**SAFETY
RECALL**

SR13-73

DATE :	DECEMBER-2013	SECTION :	06 - Electrical
SUBJECT:	P-Clamp on Bosch T1 alternators

Fig.3 Details of the P-Clamp installation on the lower BOSCH T1 alternator

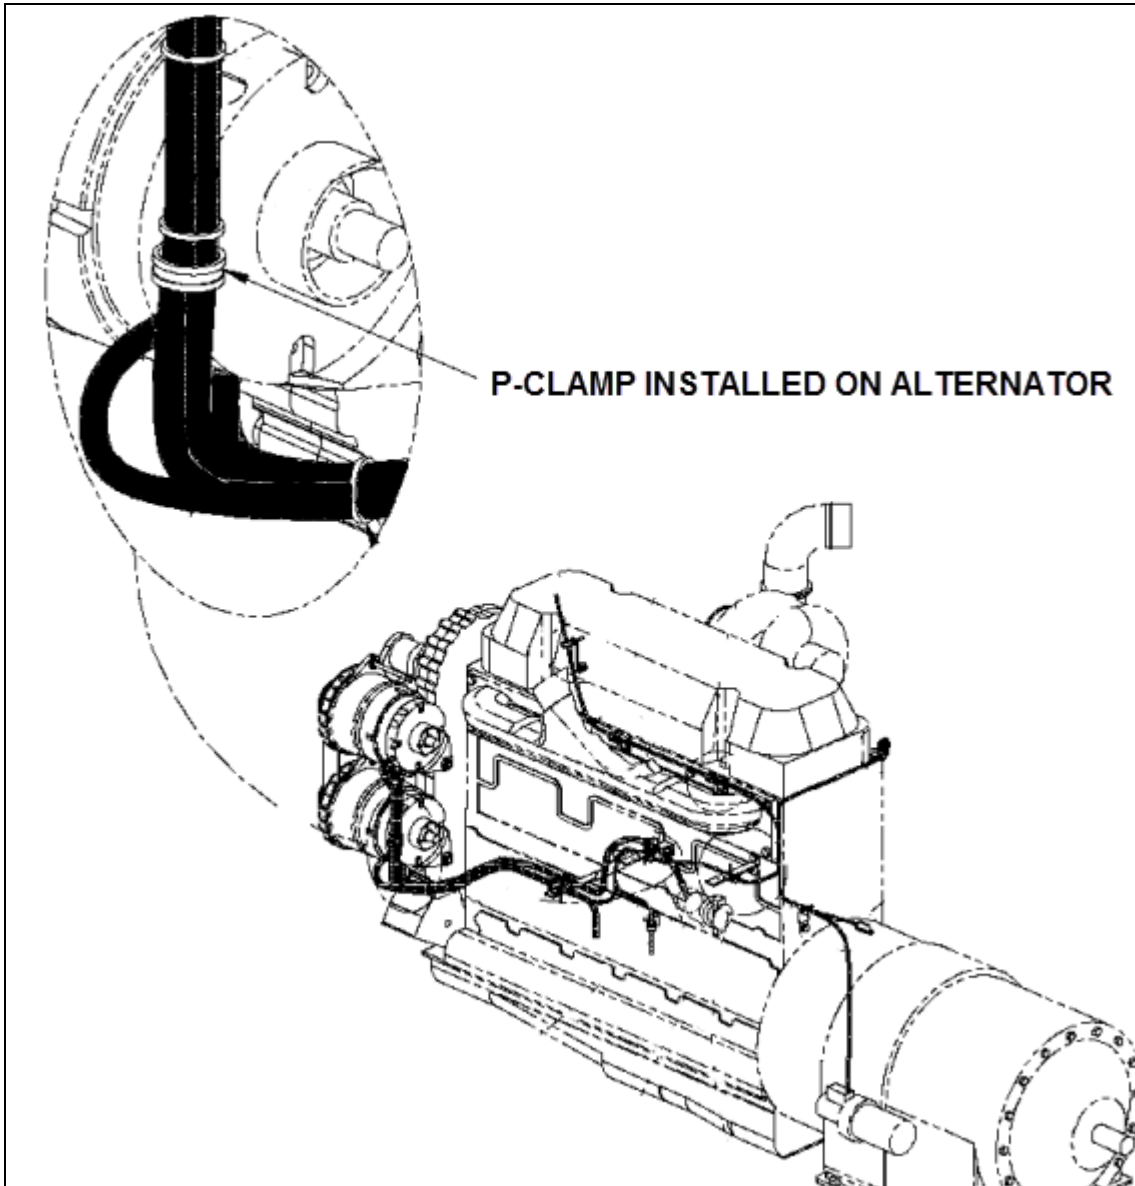
On vehicles affected by this recall, a P-Clamp may have been installed at the back of the lower alternator to hold one of the two (2) power cables coming from the upper alternator.

Since these cables run in close proximity of each other and that only one of the cables runs through the clamp, the other cable may rub against the P-Clamp which over time may result in abrasion of the cable insulation and cause a short circuit.

2. Access the rear of the alternators and check for P-clamps fixed directly to the back of the alternator bodies (Fig.3 and 4).

NOTE: In the majority of the vehicles affected by the problem, the P-clamp will be positioned on the top left corner (viewed from the back of the alternators) of the lower alternator (Fig.3 and 5) Nevertheless, inspect both alternators.

To prevent this situation, *all* P-Clamps found on the alternators bodies (upper or lower) must be removed and the power cables secured to the adjacent electrical harness.

3. Unscrew and discard *all* P-clamps found on the alternator bodies (If none were found, make sure all cables are secured as per step 4 below).
4. Using nylon cable ties, secure the cables(s) removed from the P-clamp (and all loose wires) to the vehicle power harness.

Fig.6 Upper alternator cables secured together

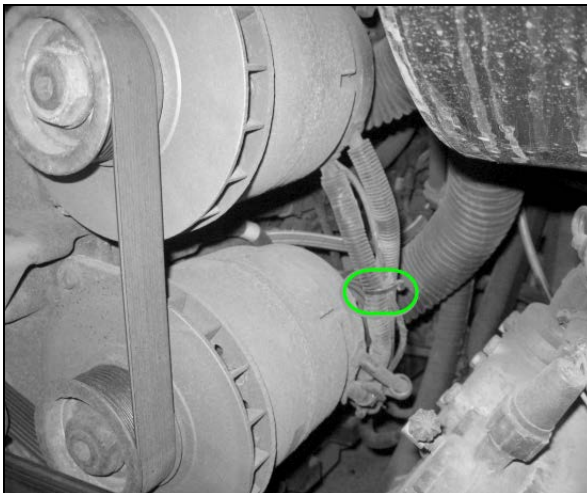
NOTE: Secure as much as possible *all cables* coming from the alternators to the main harness as shown on fig.6 and 7 below.

Fig.8 Power cables going to the starter motor

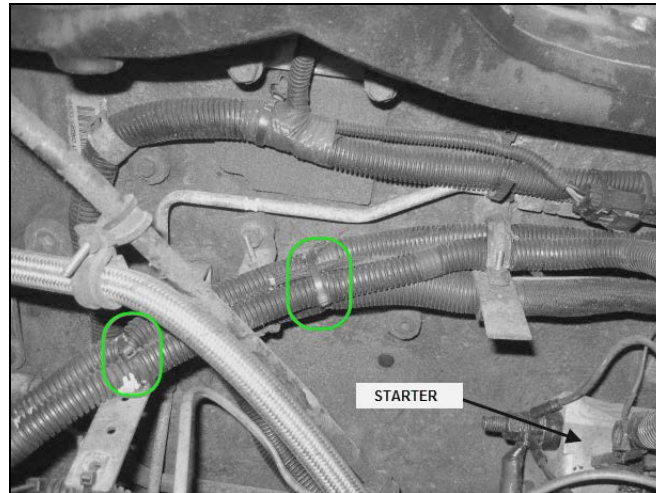
5. Make sure that the cables are correctly secured all the way to the starter unit. Ad cable ties as necessary (Fig.8)
